NESBIT SITE

Response to DMS Comments – MY2 (2023)

Nesbit Stream and Wetland Mitigation Site, Union County
Catawba River Basin, Cataloging Unit 03050103
DMS Project ID No. 100121, Full Delivery Contract No. 7868, RFP No. 16-007704
USACE Action ID No. SAW-2019-00832, DWR Project No. 2019-0862

DMS Comments Received (Black Text) & Responses (Blue Text)

CURRENT CONDITIONS PLAN VIEW

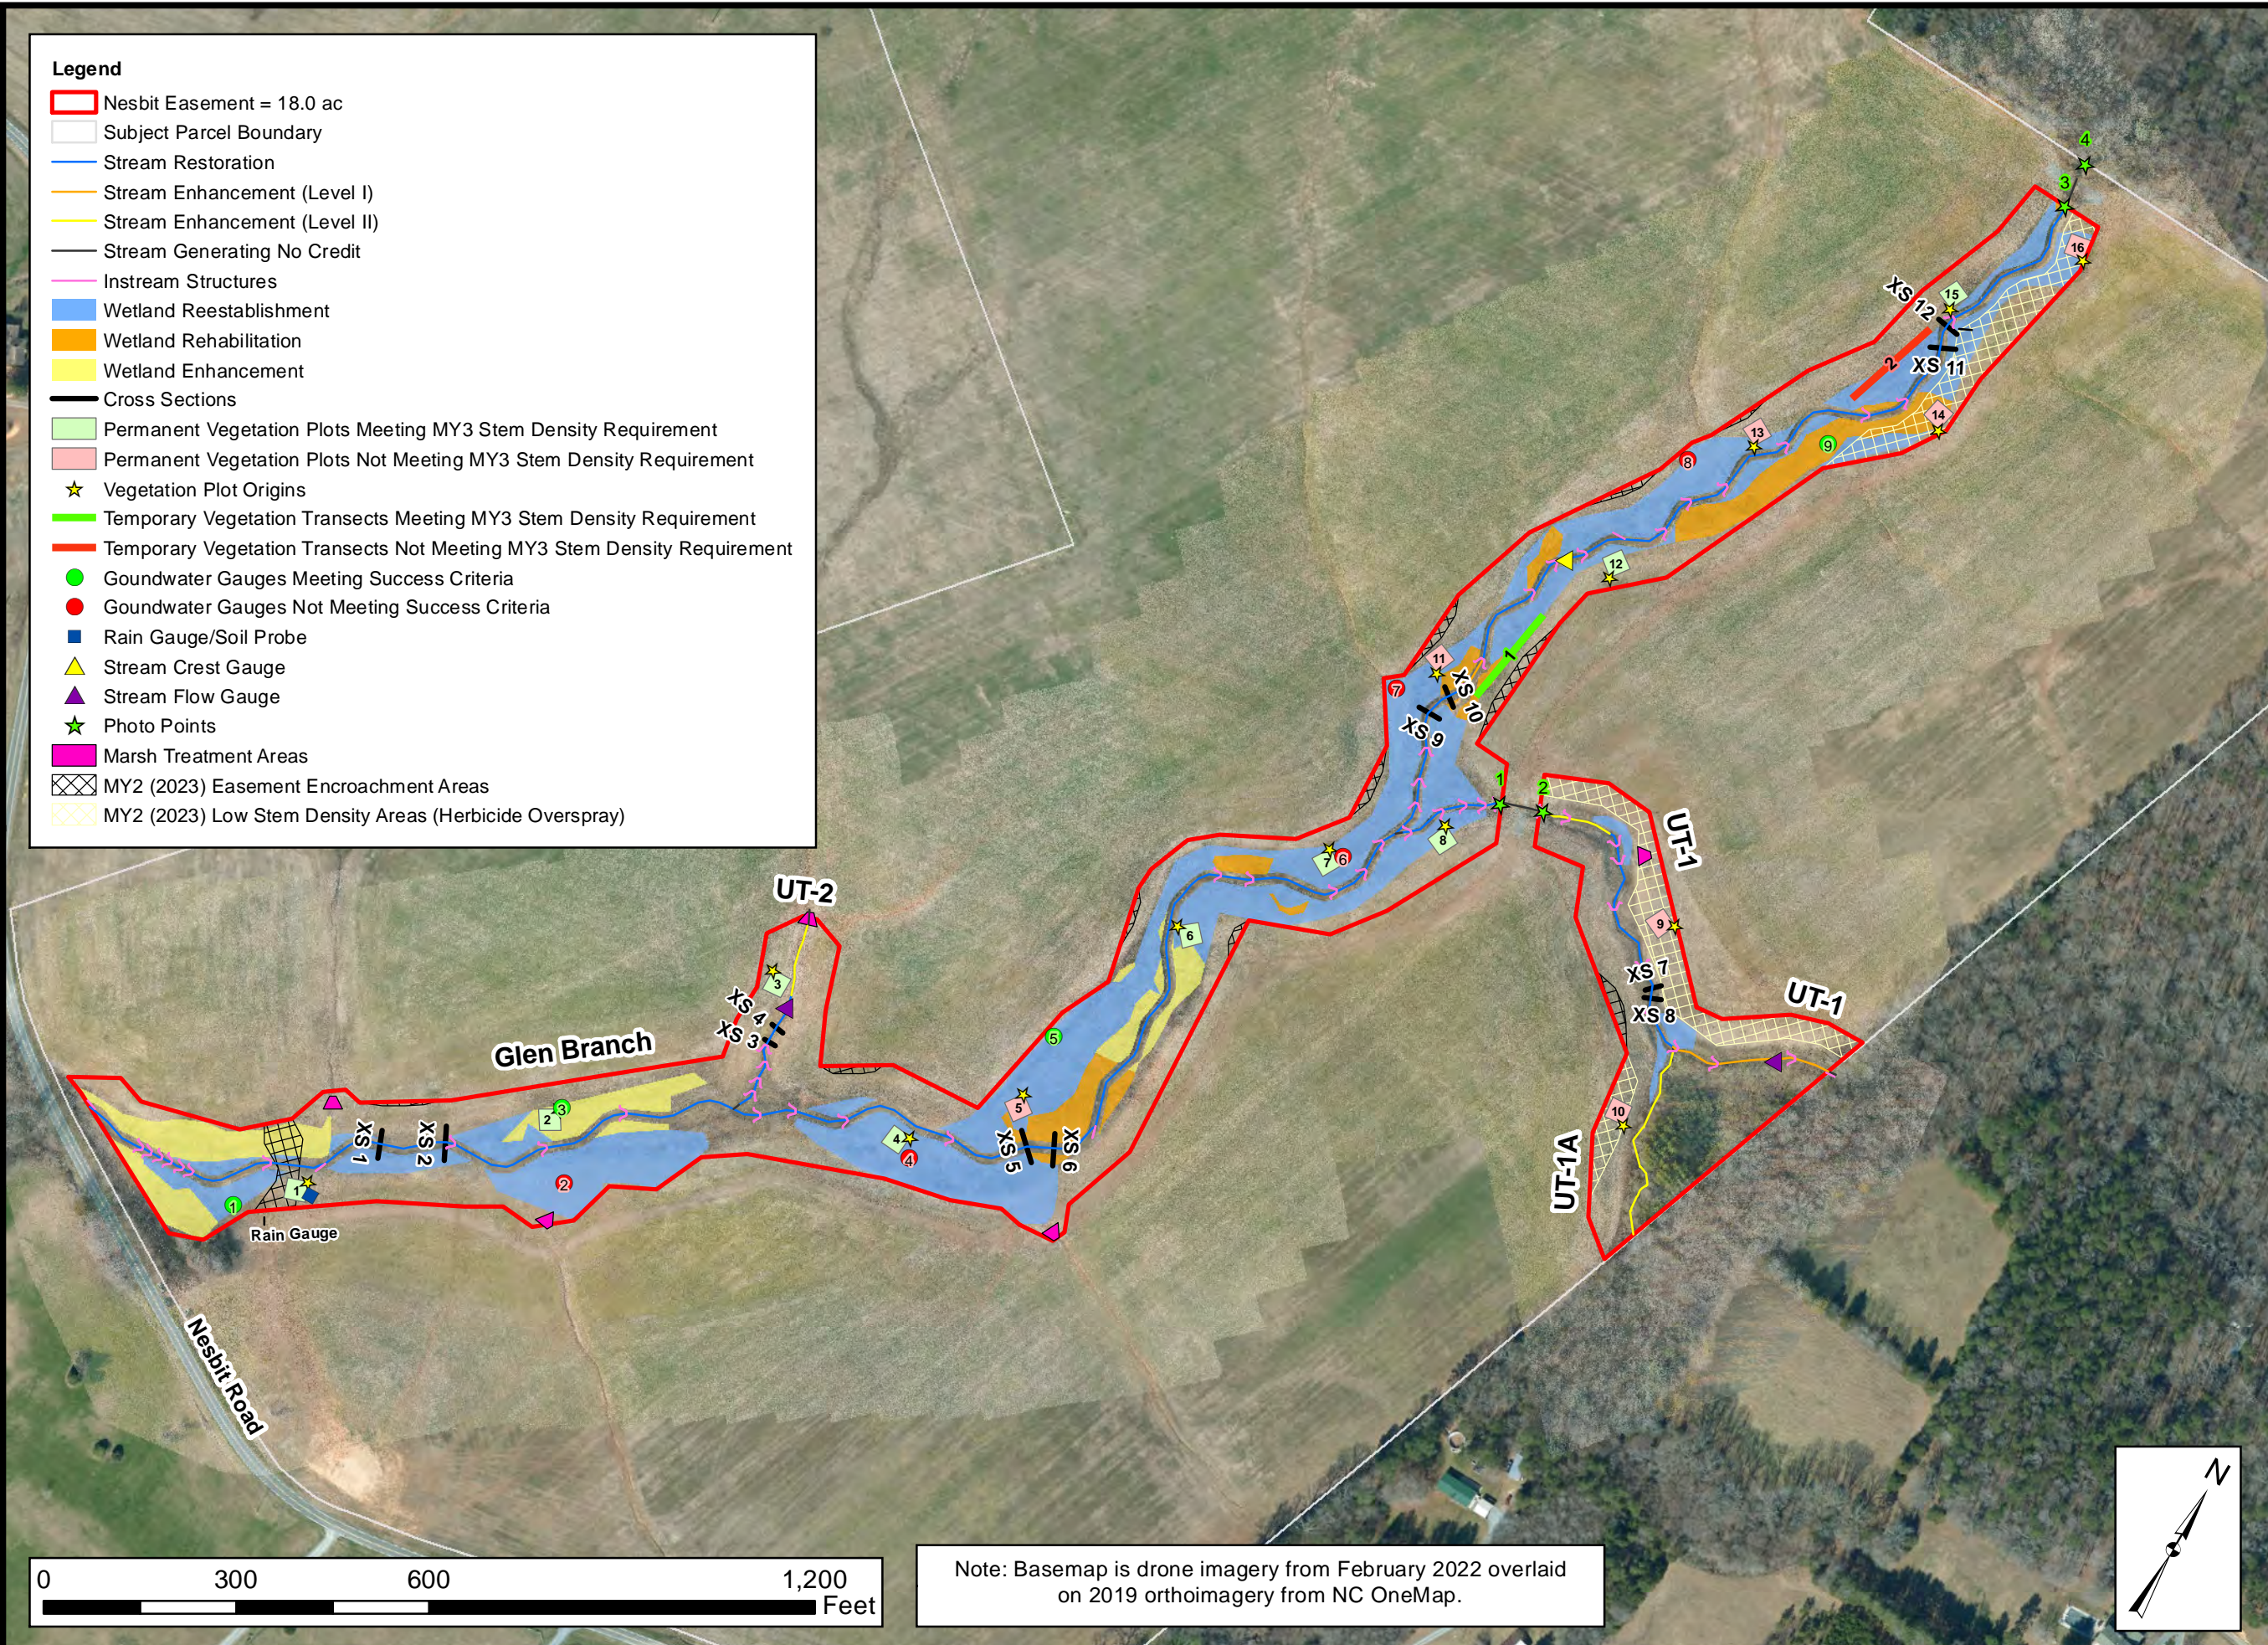
6. Appendix A. Figure 1 - CCPV: Please add the marsh treatment areas and all supplemental planting areas to the CCPV.
Response: Marsh treatment areas were added to the CCPV. No supplemental planting has occurred on site, and therefore no polygons were added to the figure.

Nesbit Glen Branch Crest Gauge MY2 (2023 Data)

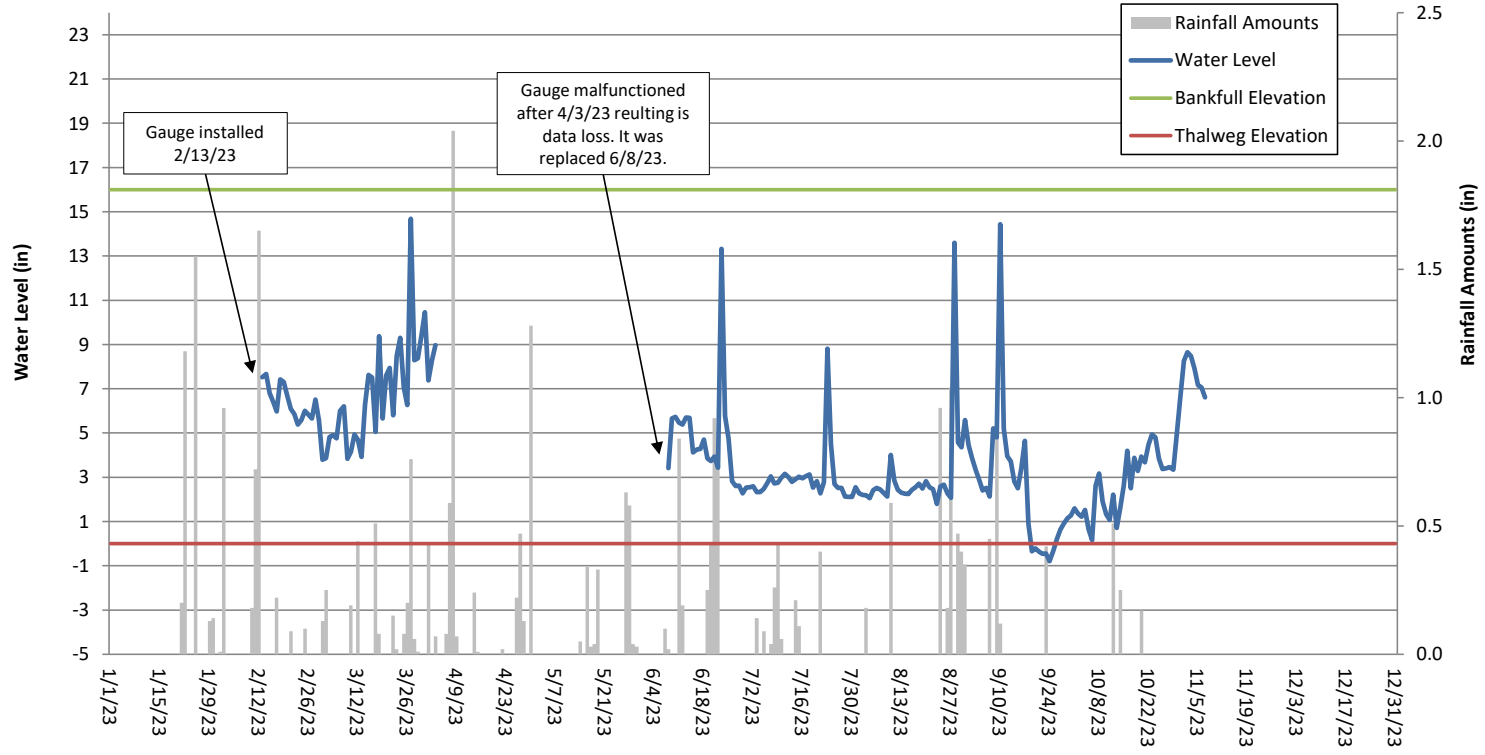
Response: Understood.
9. Appendix D. - Hydrologic Data - Nesbit Glen Branch Crest Gauge Chart: Add lines showing bankfull and thalweg to the graph and add a legend showing each linetype.

Response: Bankfull and thalweg elevations were added to the crest gauge graph. A legend was added to show each line type.
10. Appendix D. - Hydrologic Data - Nesbit Groundwater Gauge Charts 1-9: Add lines showing the ground surface and brackets showing the total number of consecutive days meeting the wetland criteria to the graphs. Add a legend showing each linetype/data point (precipitation, water level, depth criteria and ground surface).
